**ADDENDUM NO. 02  
ROAD 36 LIFT STATION UPGRADES  
Contract No. 16006  
October 6, 2020**

This Addendum No. 2 is hereby issued for the **Road 36 Lift Station Upgrades** project, and therefore made a part of and incorporated into that certain **Contract No. 16006**, referred to as “Contract Documents”).

The following electrical sheets will be replaced. Changes have been clouded.

**ROAD 36 LIFT STATION ELECTRICAL SITE PLAN - REVISED**

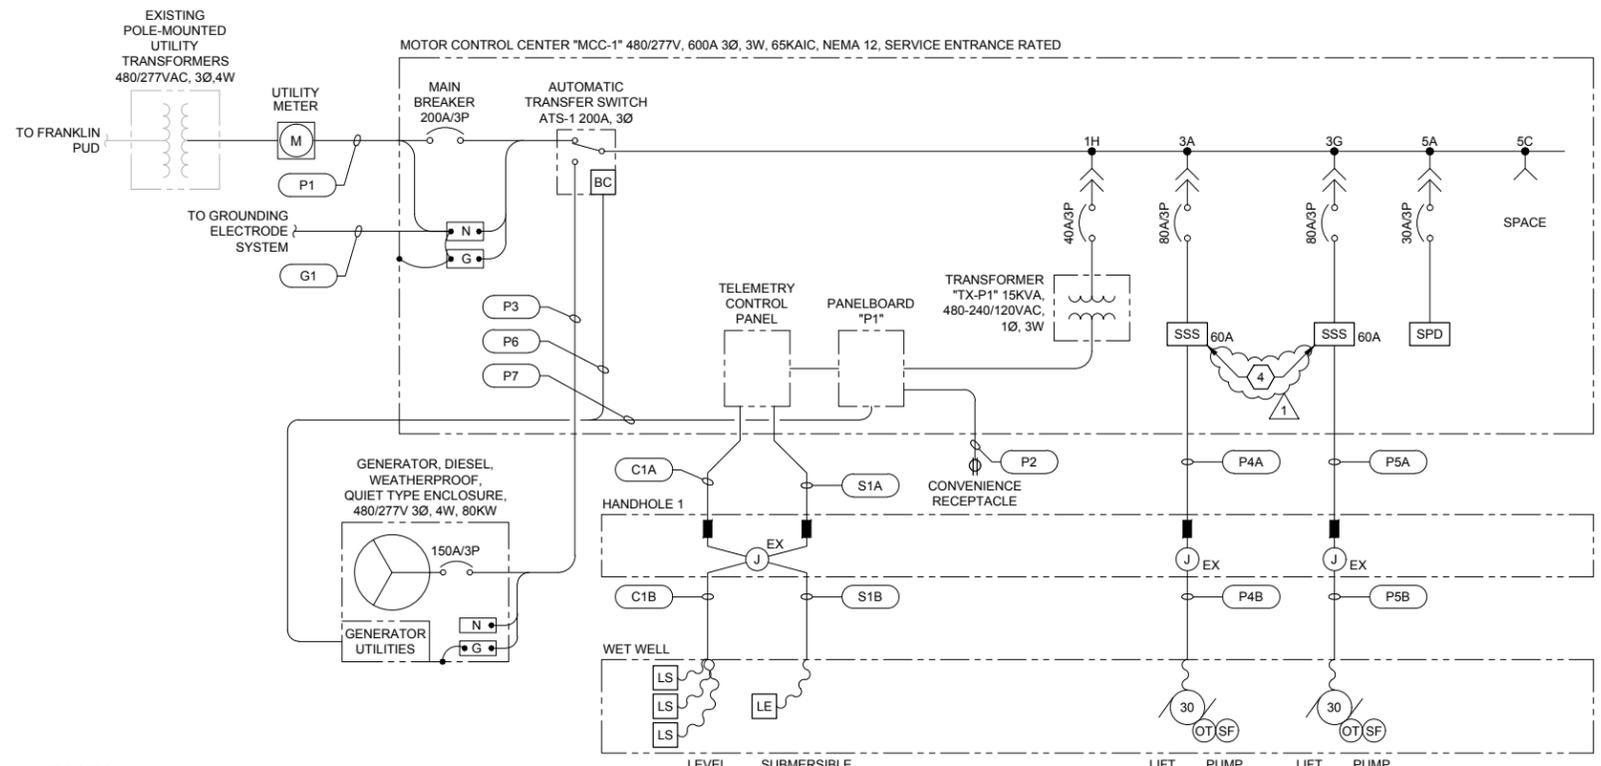
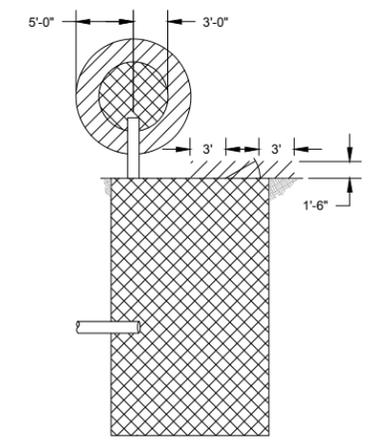
1. E004 – Road 36 Lift Station Electrical Site Plan - Revised
2. E005 – Road 36 Lift Station One-Line Diagram
3. E006 – Road 36 Lift Station Electrical Details
